TITLE: AIR CONDITIONING - AVIONICS EQUIPMENT VENTILATION - INSTALL PALL FILTER INSTEAD

MODIFICATION No.: 24146P3462, 26739P5104, 27038P5162, 34885P8785

This page transmits Revision No. 44 of Service Bulletin No. A320-21-1087

DATE: Mar 17/95 SERVICE BULLETIN No.: A320-21-1087

Figure 1, Sheet 1 Config. 01, 03:Removal/Installation of the Filter

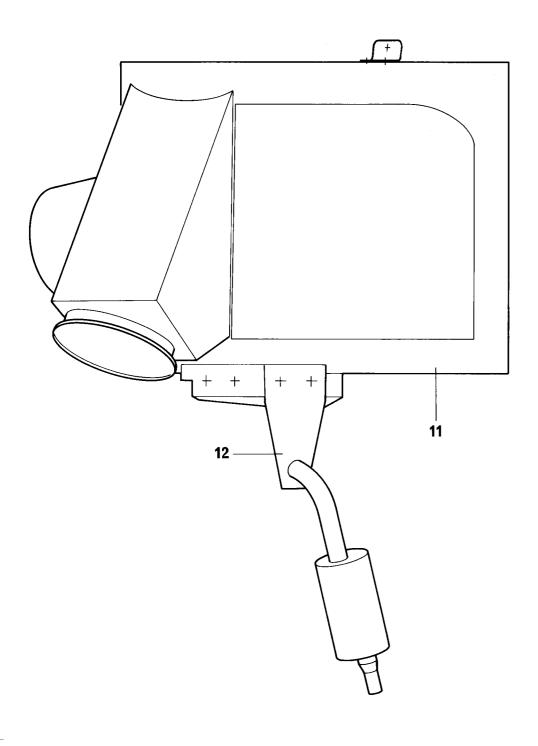
- (1) Config. 01
 - (a) Remove the LE BOZEC filter Refer to Figure 1

Install the PALL filter (b) Refer to Figures 1 and 4 (Refer to CMM 21-26-02)

1 Insta	all:		
_ 1	Filter Housing	QB0555	Item 11
2	Bolt	NAS1303-3	Item 10
2	Nut	NAS1726-3	Item 9
1	Flexible Sleeve		Item (7)
4	Clamp		Item (6)
1	Clamp		Item (8)
1	Flexible Sleeve		Item (2)
4	Clamp		Item (1)
1	Tube Assembly	QB0553	Item 12
12	Bolt	(*)	Item 13
12	Washer	(*)	Item 14

Figure 2, Sheet 1 Config. 02, 04:Removal/Installation of the Filter

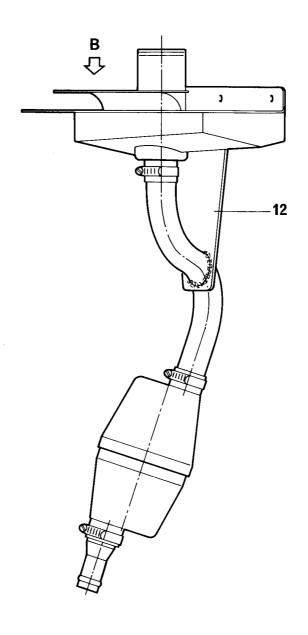
(a) Remove the LE BOZEC filter Refer to Figure 2

(b) Install the PALL filter Refer to Figures 2 and 4 (Refer to CMM 21-26-02)

<u>1</u> In	stall:		
1	Filter Housing	QB0555	Item 11
2	Bolt	NAS1303-3	Item 10
2	Nut	NAS1726-3	Item 9
1	Flexible Sleeve		Item (7)
2	Clamp		Item (25)
1	Clamp		Item (8)
1	Flexible Sleeve		Item (2)
2	Clamp		Item (24)
1	Tube Assembly	QB0553	Item 12
12	Bolt	(*)	Item 13
12	Washer	(*)	Item 14
1	Drain Hose		Item (5)
1	Clamp		Item (3)
1	Packing	NSA8203-260	Item 20
1	Filter Cartridge	QB0511	Item 15

Figure 3, Sheet 1 Config. 06:Removal/Installation of the Filter

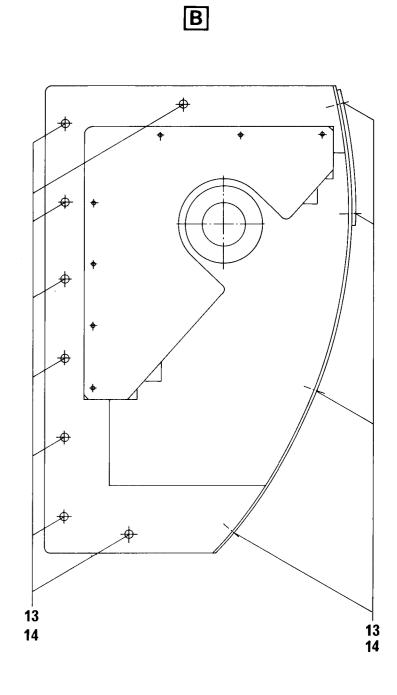
- (6) Config. 06
 - (a) Remove the LE BOZEC filter Refer to Figure 3
